H22-19
Hotel Redevelopment
REVISED

Property Owner: Legacy Hotel of Medina LLC
Applicant: Jim Gerspacher
Location: 257 South Court Street
Zoning: C-2 (Central Business)
Request: Certificate of Appropriateness revisions for the construction of a hotel

The current application requests modifications to the south and east sides of the first floor of the building and minor site changes.

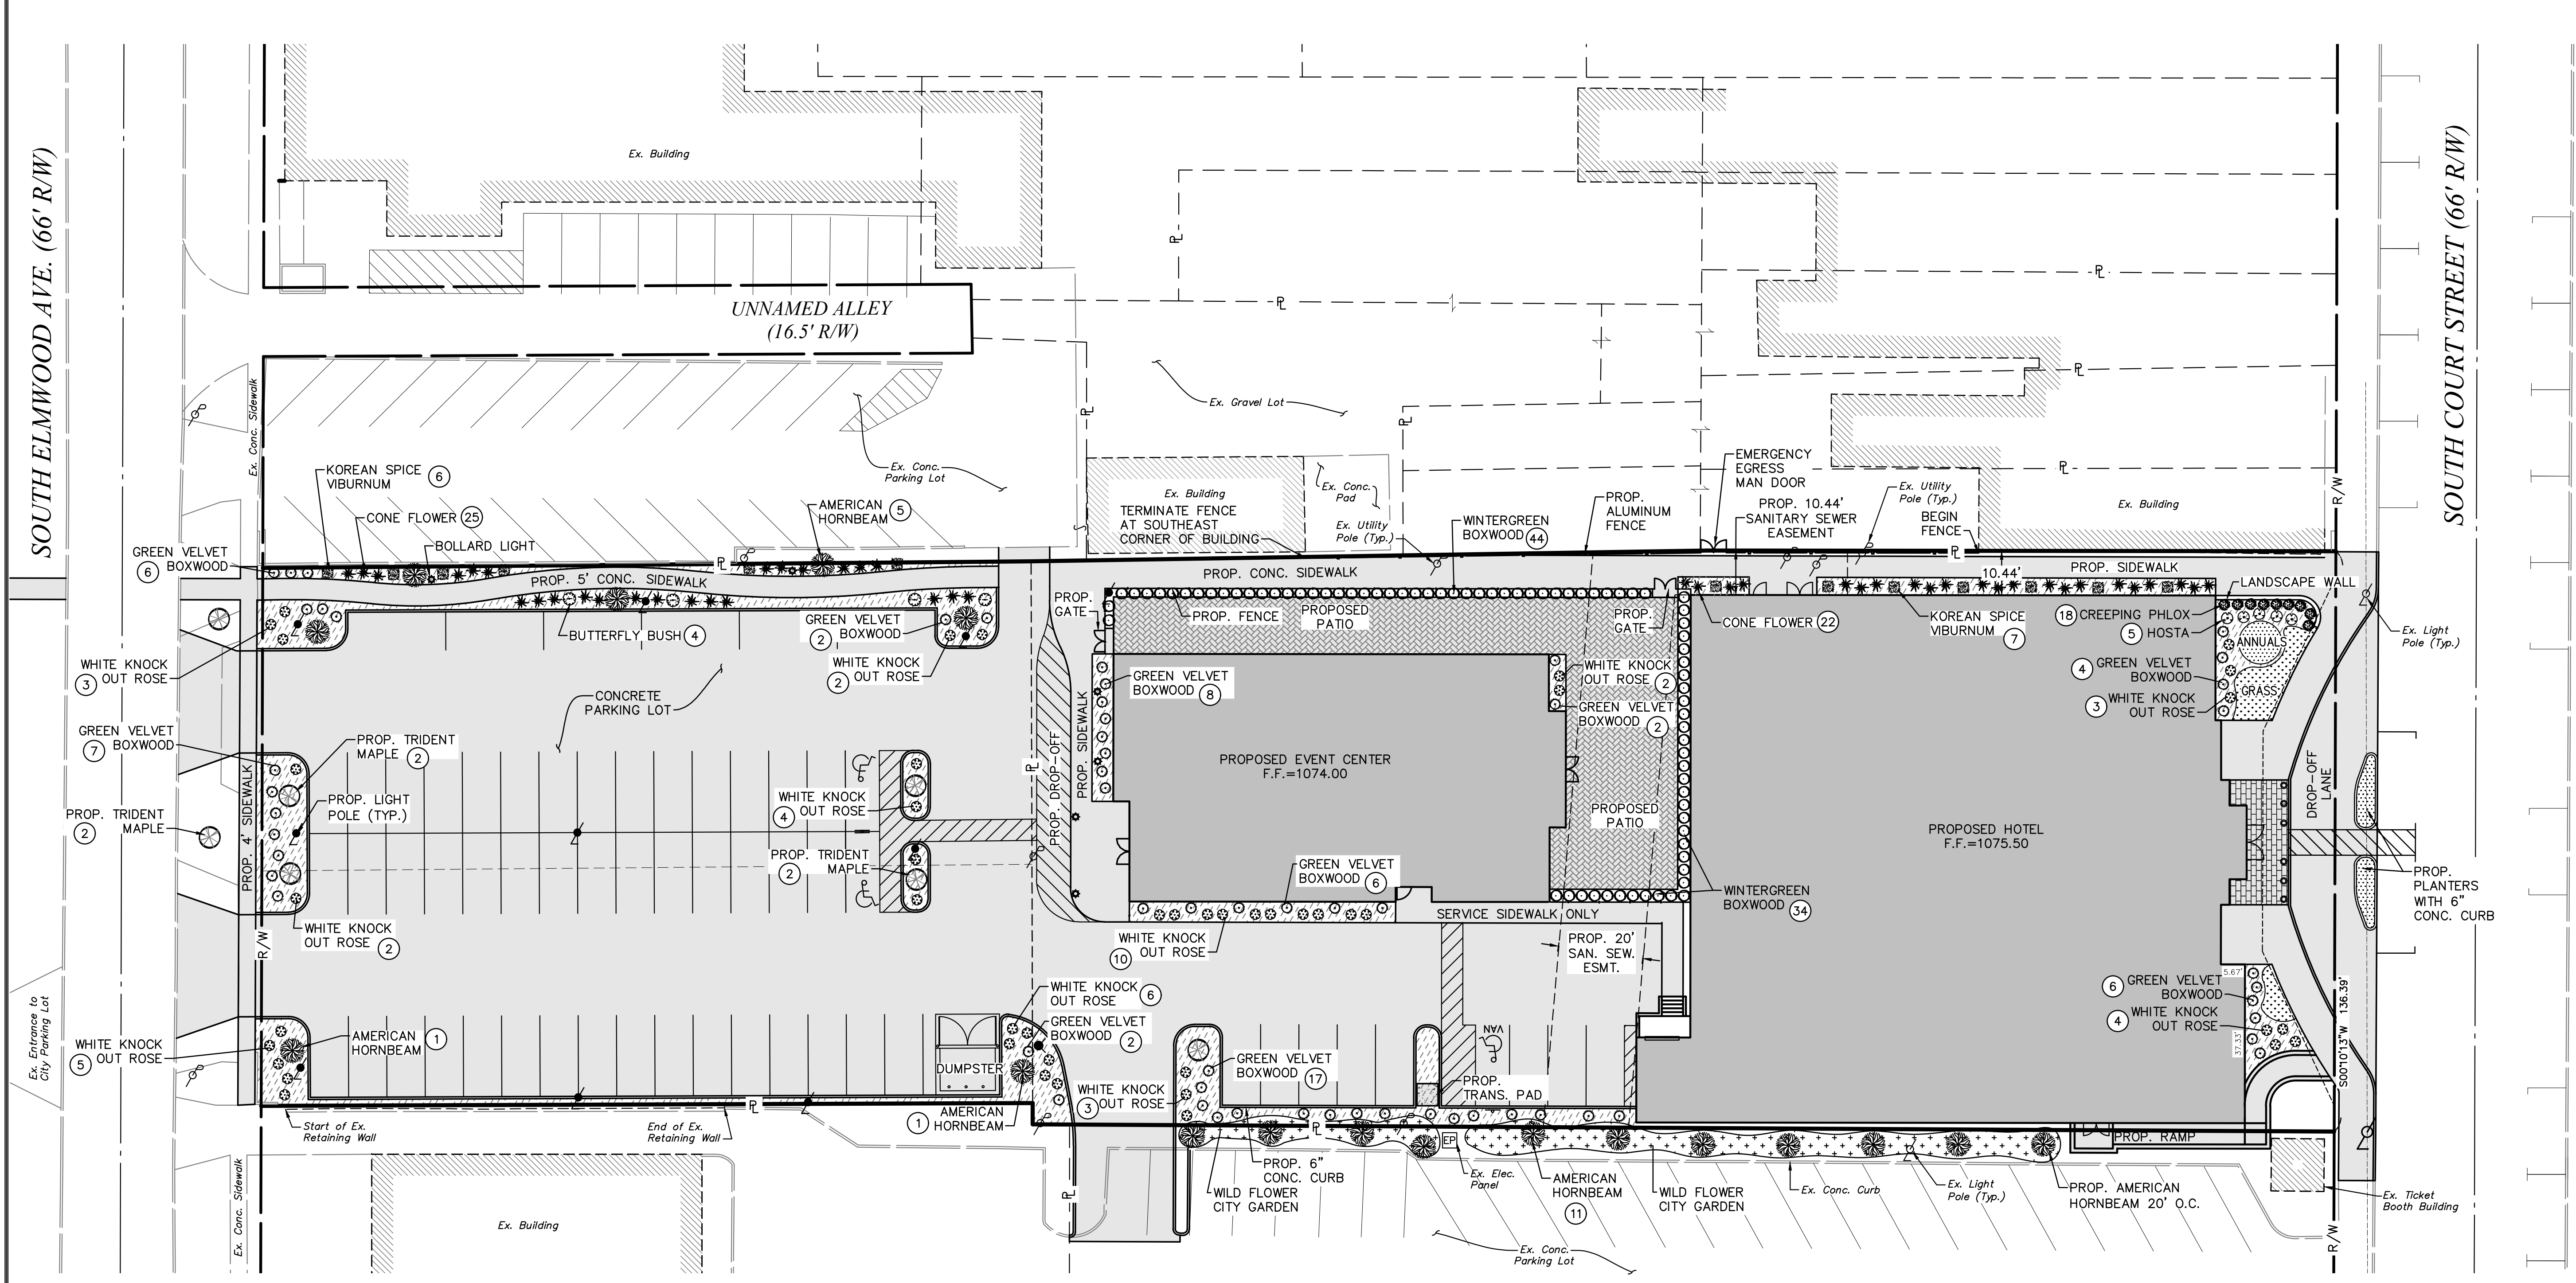
Site (Southeast Corner)

Approved 5/9/24

- Landscaping between the hotel and the sidewalk
- A ramp/walkway connecting the sidewalk to an entrance on the south side of the building, incorporating a black metal railing, and partially located on the Feckley Lot property

Proposed

- A hardscaped area with steps, a patio area, and potted plants south of the main entrance between the hotel and the sidewalk
- The connection of the ramp/walkway to the Feckley Lot via the aforementioned stairs
- A hatched area in one or more parking spaces in the Feckley Lot

Staff recommends revised approval of H22-19 retaining the following condition from the previous approval: The applicant shall repair any unreasonable damage to the building at 241 South Court Street caused by the demolition of buildings at 253 or 257 South Court Street. In addition, as noted, separate approvals will be necessary for all proposed signs.
